Review of the MOE Turbine Noise Compliance Test at the Libby Home

John Harrison, PhD.

May 2013

Figure 1: Measured sound pressure level (SPL) as a function of 10m wind speed.

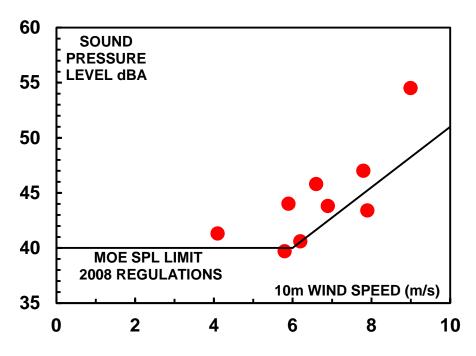
Figure 1 is a plot of the measured sound pressure level as a function of the 10 metre wind speed, V(10m). The solid line corresponds to the MOE noise limit for a class III

environment. It is 40 dBA up to a 10m wind speed of 6 m/s, rising to 51 dBA at 10 m/s. There are no qualifiers for humidity.

Clearly, the turbine noise is out of compliance for much of the time. Remember that the prediction was 38 dBA.

Figure 2: Corrected sound pressure level for a height of 4.5m

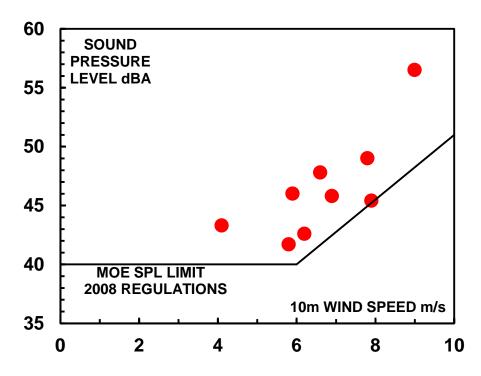
The 2008 MOE noise regulations specify that the prediction is to be made for a location at the centre of the residence at a height of 4.5m. The sound pressure level at this location is typically 2 dBA higher than at a location 1.5m above ground outside the home¹. Therefore the measurements made by MOE at a height of 1.5m have been corrected by adding 2 dBA. The corrected sound pressure levels, to be compared with the Ontario regulation, are shown in Figure 2 below. The sound pressure levels at the Libby home were up to 8 dBA above the regulation and clearly out of compliance. Furthermore, the measured sound pressure levels were up to 10 dBA above the predicted sound pressure levels at the residence.

Figure 3: Diurnal wind shear exponent pattern at Lamar, CO, for 52-113-m levels.

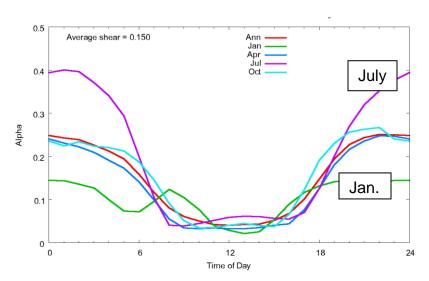
Figure 3 shows measurements of the wind-speed gradient parameter, measured by M. Schwartz and D. Elliott (NREL); these measurements are typical as will be well-known to the acousticians at MOE.

Typically, at night during the summer month the turbine noise is going to be higher and more noticeable than during the winter months. Therefore the measurements made in December do not catch the full impact of the turbine noise at the Libby home.
